## EDUCATION VILLAGE PARCEL E & F

### SUMMARY

# MASTER PLAN ANALYSIS

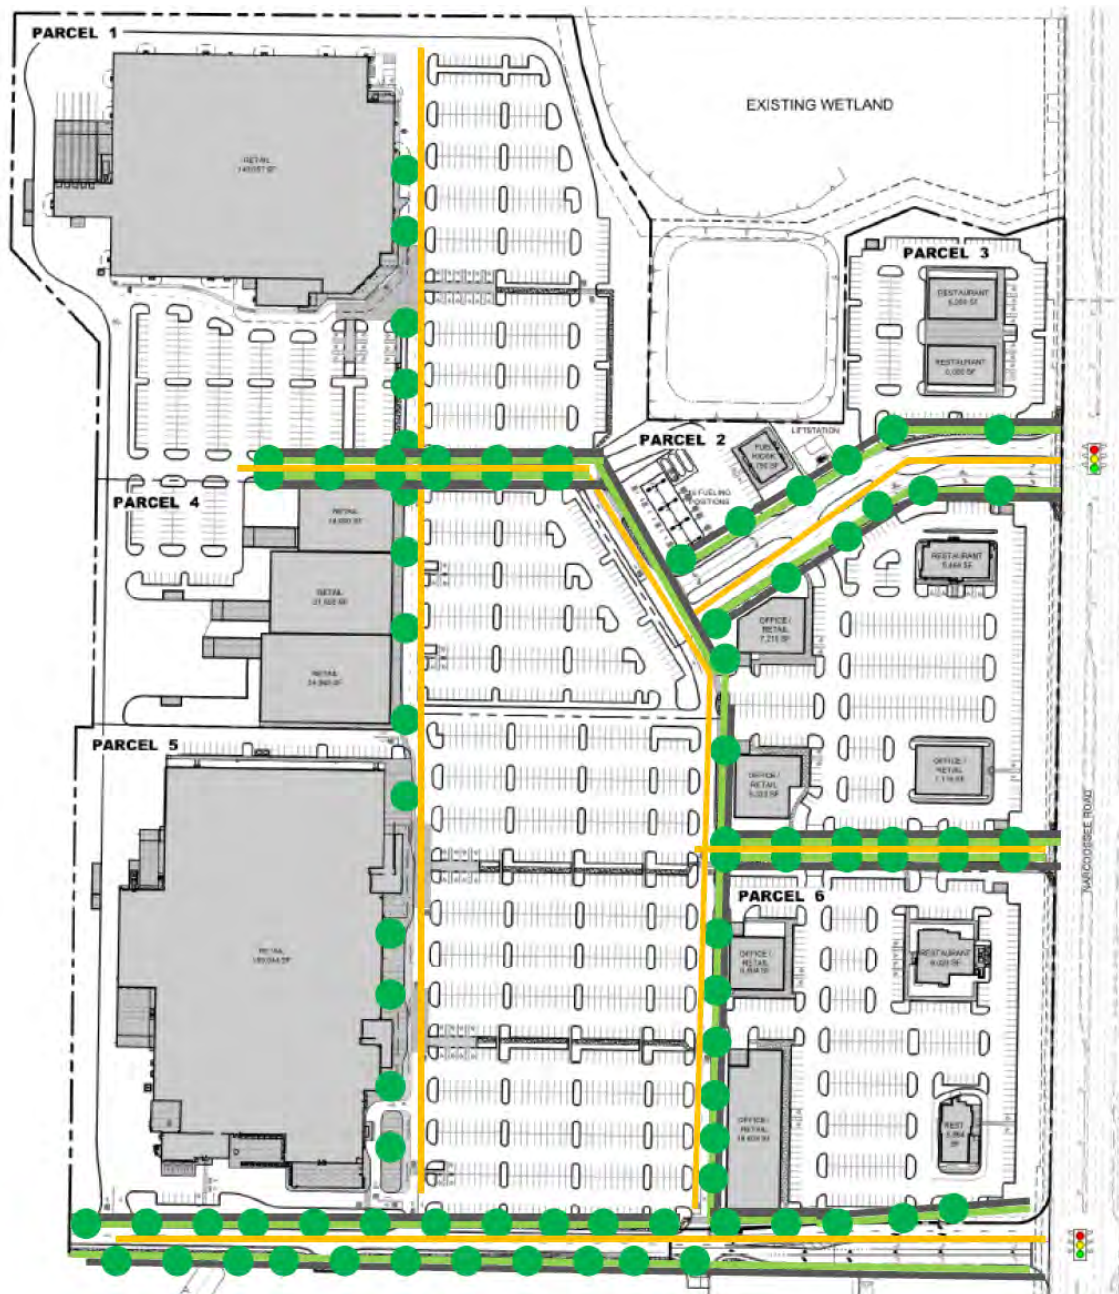
Aerial photos show existing trees south of the retention pond. Consider moving the Parcel 2 Gas Station and replace with a restaurant or other outdoor use that can benefit from tree cover.

According to LDC Section 61.221(a), it states that “development shall provide multiple direct vehicular and pedestrian connections in its local street system and internal circulation to and between nearby local destinations, such as transit stops, parks, schools, residences, workplaces and shops, without requiring the use of arterial streets.” Urban Design Condition #12(b) of this report states, “A minimum of one pedestrian connection shall be provided from each parcel (as depicted on the exhibit provided identifying each parcel) from each public or private street, to the main entrance of each building. Multiple tenant buildings may consolidate to one connection if cross connections are provided.” And Urban Design Condition #12(e) states, “The main vehicular drives, pedestrian areas in front of the large retail stores, and the north/south vehicular drives between parcels 5 and 6 shall be designed to appear as streets, with street trees within minimum 7 foot wide park strips adjacent to the curb, and a minimum 5 foot wide sidewalk.” The diagram below explains these conditions in graphic form.

# PROPOSED SITE PLAN/PRELIMINARY PLAT

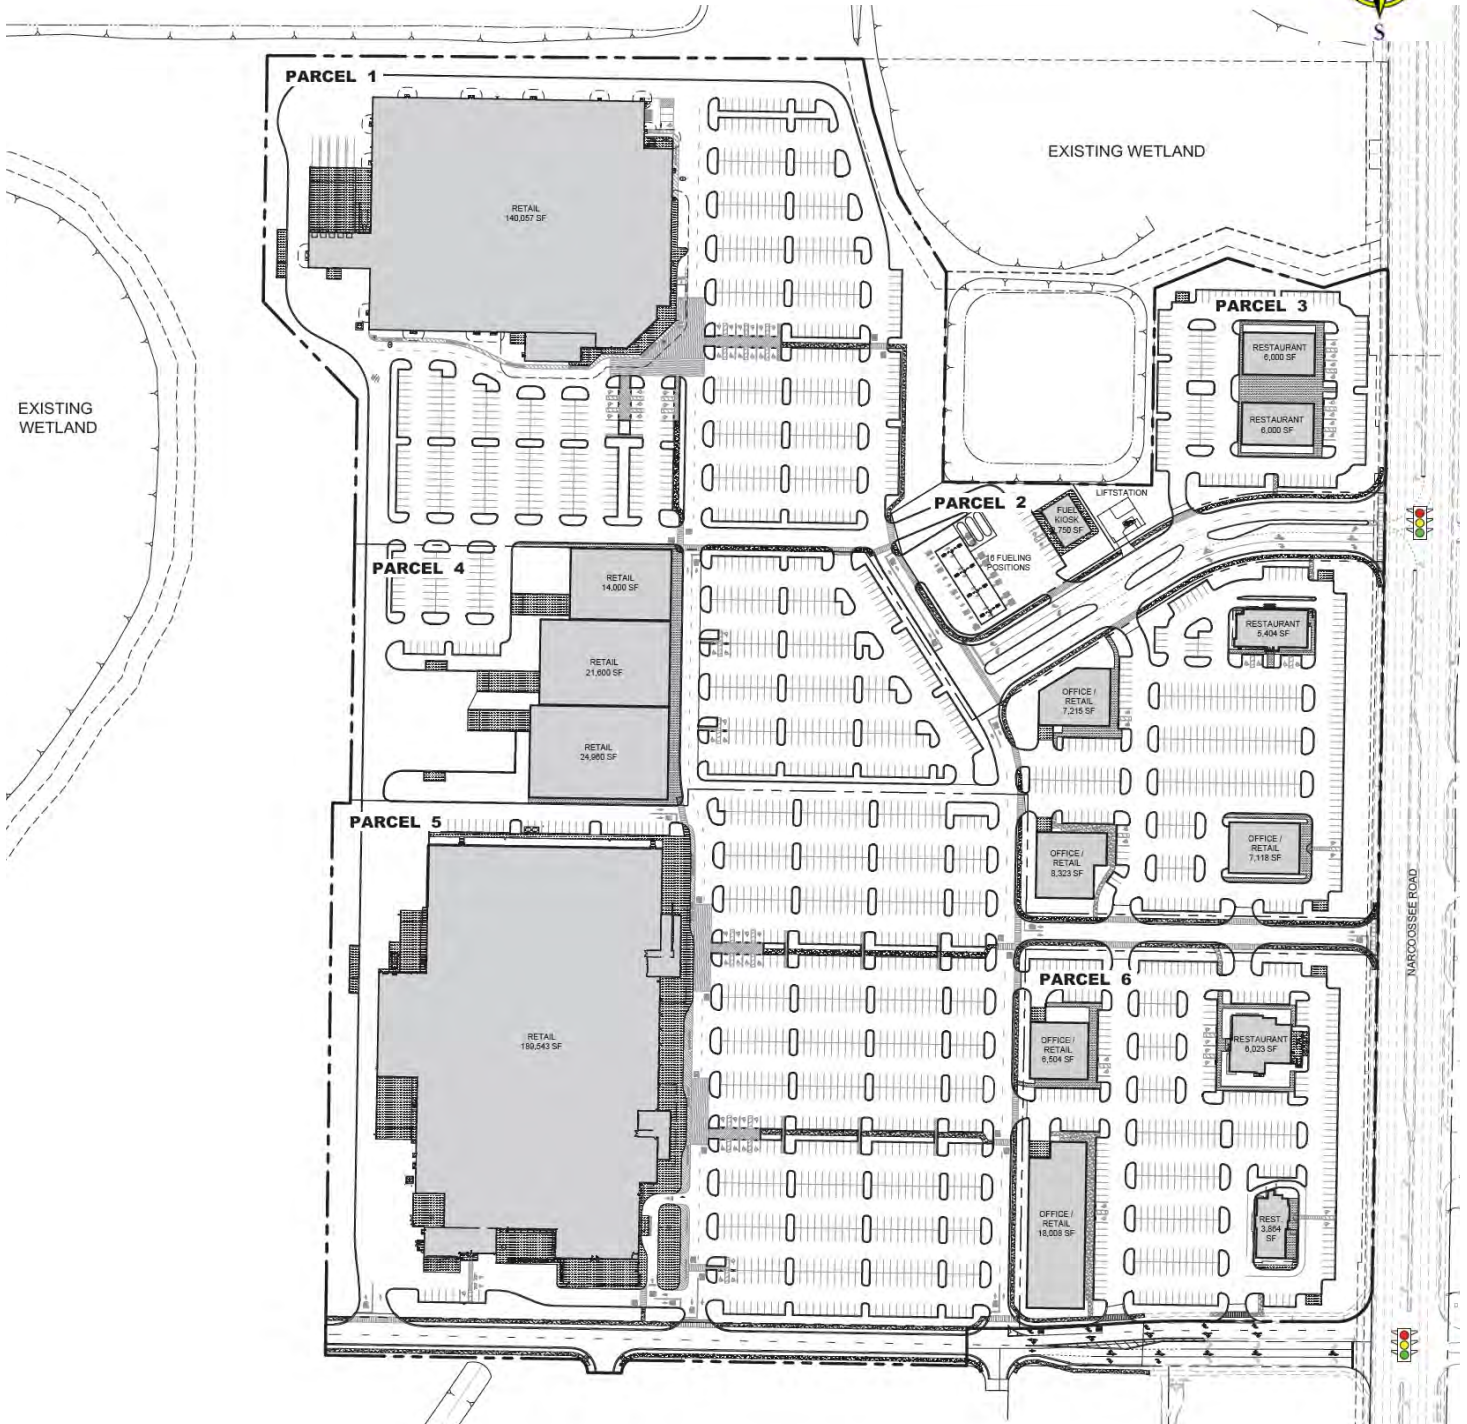
2. In Parcel 6, the multiple north and south curb cuts will be combined to one and a drive aisle that runs north and south will connect each of the sub-parcels. This will help with circulation of proposed drive-thru's and reduce multiple conflicts on interior roads.

3. The curb cut on Tagore Place from Parcel 6 shall be a right-in/right-out only. A physical barrier shall be placed at the driveway to accomplish this.

6. Realign the center drive aisle on the north side of Parcel 6 that runs perpendicular from Narcoossee Rd, this can be accomplished by decreasing the size of the median on the eastern side of Parcel 5 or by increasing the offset to create a "T" intersection.

8. Drive thru currently shown at "Big Box" retail location does not meet Orlando LDC requirements. Design issues will be worked out during permitting stage.

# ARCHITECTURAL ELEVATIONS—PARCEL 5

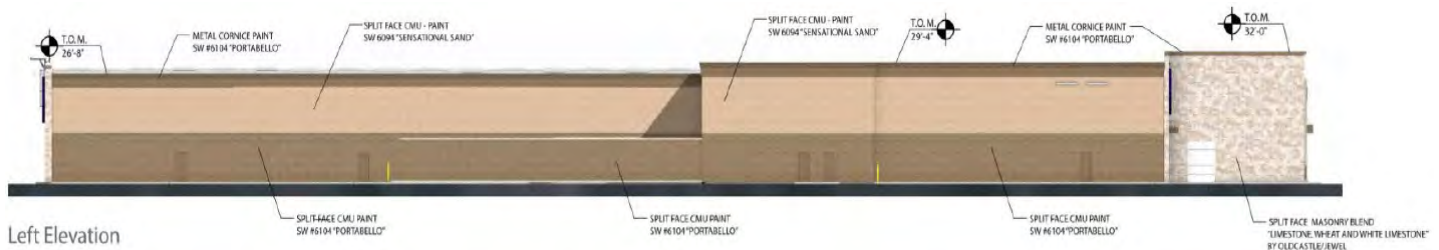
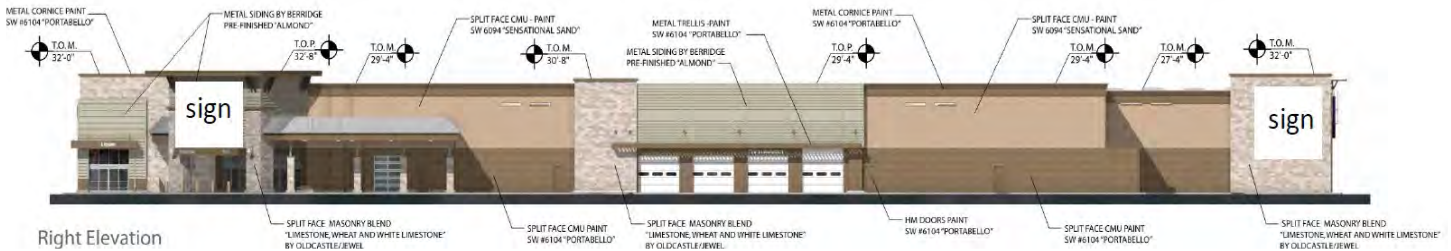
Elevations were provided for the grocery store and bulk-retail store. All other retail buildings and out parcels shall require an appearance review through Planning Official determination prior to submitting to Permitting.
